ZAMBIA – TANZANIA INTERCONNECTOR PROJECT

Package 4

CLARIFICATIONS NO. 2 TO BIDDING DOCUMENTS

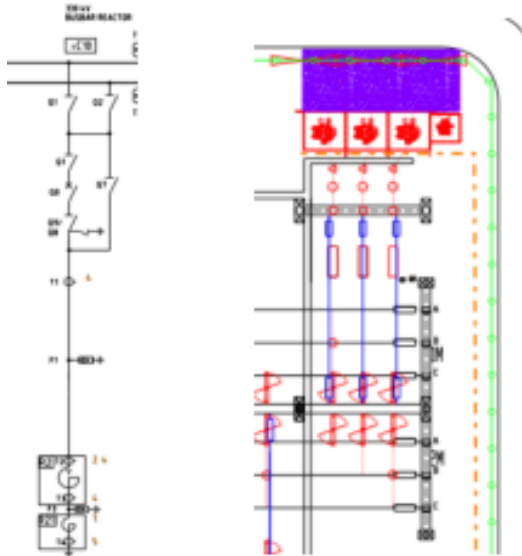
449.	12.8.5	Section VII – Employer's Requirements	N	Section VII – Employer's Requirements Package 4 - NAKONDE STEPDOWN (330/(132)66/11KV) SUBSTATION 12.8.5 Specific Requirement The total breaking time (opening time plus duration of the arc) of the breakers shall be as short as possible, but in no case is it to be longer than 40	Refer to RFC 220 and addendum 3 S.No 11

S. No.	Specification Clause	Document Reference	Addendum Required [Y/N]	REQUEST FOR CLARIFICATION ON	EMPLOYER'S RESPONSE
				msec. Please accept Total breaker time of ≤ 45 ms as most OEM's are not complying the same.

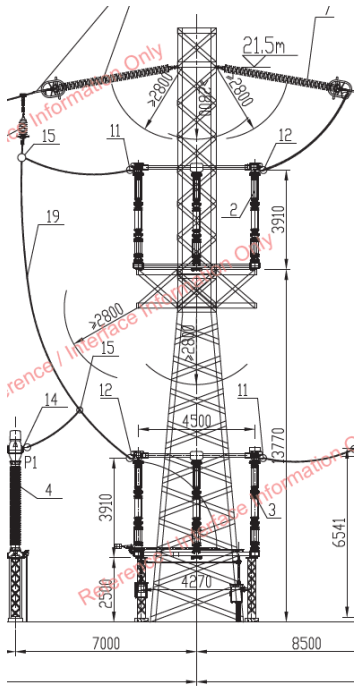
459.		Drawings Technical Schedules	N	D-330 kV Nakonde Stepdown Substation SLD; B-KASAMA-SLD; 19 SCHEDULES OF GUARANTEED TECHNICAL CHARACTERISTICS-2.5. 330 kV Current Transformer Line Feeder Bay 2.6. 330 kV Current Transformer - Transformer Bay (Page 779-780) SLD:3.) 330 kV Line/Bus Coupler feeder bay Current Transformer 1200-2400/1/1/1/1/1/1 A, 5P20/PX/PX/PX/0.2s/0.2s, 10/10/10/10/5/5 VA	Refer to RFC 23 and addendum 3 S.No 2

S. No.	Specification Clause	Document Reference	Addendum Required [Y/N]	REQUEST FOR CLARIFICATION ON	EMPLOYER'S RESPONSE
				Technical Schedule: Protective cores number and class 1x 5P20 3 x class PX 0.5V/turn Measuring cores number and class: 2 x 0.2s Fs<5 Spare core: 1 x class PX 0.5V/turn The CT current ratio and core quantity in the single line diagram do not match the requirements in the Technical Schedule. We recommend following the values specified in the Technical Schedule and provide the updated single line diagram in the technical proposal.	
460.		Drawings	N	D-330 kV Nakonde Stepdown Substation SLD; C-NAK-330 kV Nakonde Stepdown Substation Layout	Refer to amended drawings PP-ZTIP-P04-ODSS-C109_Nakonde SS GA_R00_30062026 and D-330 kV Nakonde Stepdown Substation SLD_REV03_30062026

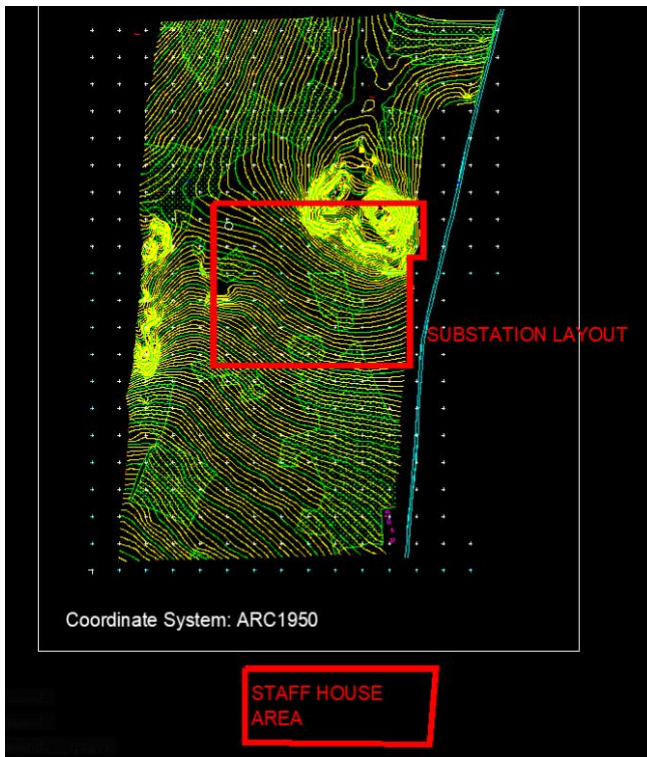
476.	RFC 354	ZTIP_RFB_Clarifications_Pack4_30062026	N	The 110°C requirement applies to the auxiliary wiring at fan motors, oil pumps, and monitoring devices mounted on the transformer tank.	Refer to Section VII 12.12.48: "Power cables shall be of XLPE insulated, with steel armouring, rated

S. No.	Specificati on Clause	Document Reference	Addendu m Required [Y/N]	REQUEST FOR CLARIFICATION ON	EMPLOYER'S RESPONSE																																																																																																																														
				According to the clarification response, some cables are required to withstand temperatures of 110°C. Can the material of such cables be determined by the design team?	<i>voltage 1 kV, 50 Hz. The conductors shall be copper for cables ≤ 36 kV and of aluminium for cables >36 kV. Control cables shall be PVC-insulated, rated voltage 300/500 V, 50 Hz and shall be steel armoured. The conductors shall be highly flexible stranded copper.”</i>																																																																																																																														
477.		Drawings	N	PP-ZTIP-P04-ODSS-C108_Nakonde Site Plan_R00_30062026

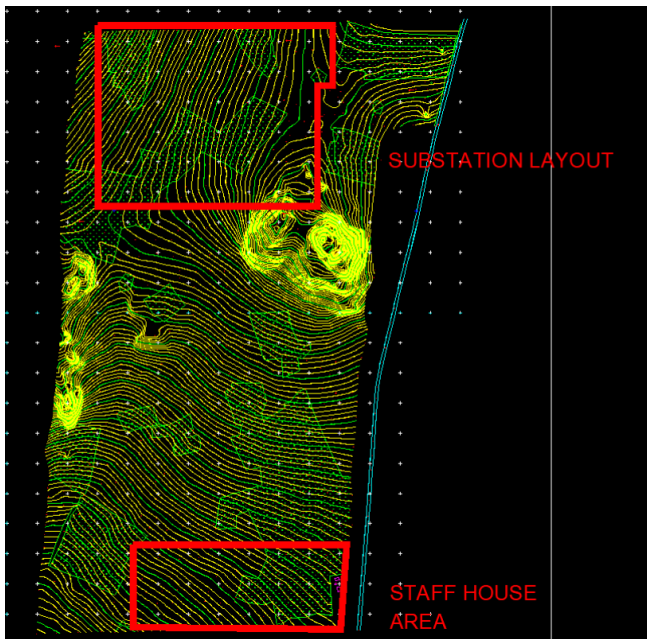
S. No.	Specificati on Clause	Document Reference	Addendu m Required [Y/N]	REQUEST FOR CLARIFICATION ON	EMPLOYER'S RESPONSE																																				
				Based on the provided WGS84 coordinate points, Converted to the ARC 1950 system and positioned on the topographic map, The location is off. Please provide the topographic map for WGS84 or coordinate points for ARC 1950.																																					
478.			N	11052026_ZTIP_RfB_NAKONDE SUBSTATION_PACKAGE 4_ISSUED/Page 229
